# 100GBASE-DR, FR1, and LR1 Average Power Min specs

# Comment 54

C/ 140
 SC 140.6
 P41
 L18
 # 54

Table 140–6—100GBASE-DR, 100GBASE-FR1, and 100GBASE-LR1 transmit characteristics

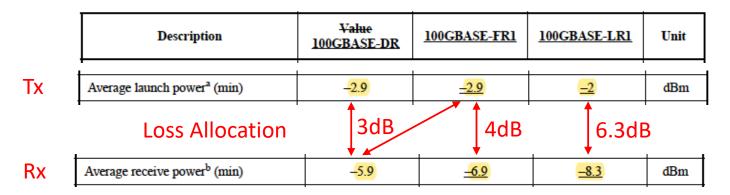
The Average launch power max for 100GBASE-FR1 is calculated for an extinction ratio = ~14 dB. This is inconsistent with 100GBSE-LR1 as well as with 400GBASE-FR4 and 400GBASE-LR4-6, which all use an infinite extinction ratio in this calculation.

Use an infinite extinction ratio to calculate the Average launch power max for 100GBASE-FR1. Replace the value of -2.9 dBm in Table 140-6 with -3.2 dBm

- Different ER values are used to calculate the Average launch power (min) for the three PMDs
- Using an infinite ER for 100GBASE-FR1 would result in Average launch power (min) = -3.2 dBm

PROPOSED REJECT.

We presume the commenter intends to modify Average launch power (min), not the maximum. If implemented this change would affect Average receive power (min) for -FR1.

Additionally the change would limit interop between -FR1 and -DR to less than the 3dB -DR channel. Maximum loss in the -FR1 to -DR direction would become 2.7 dB.
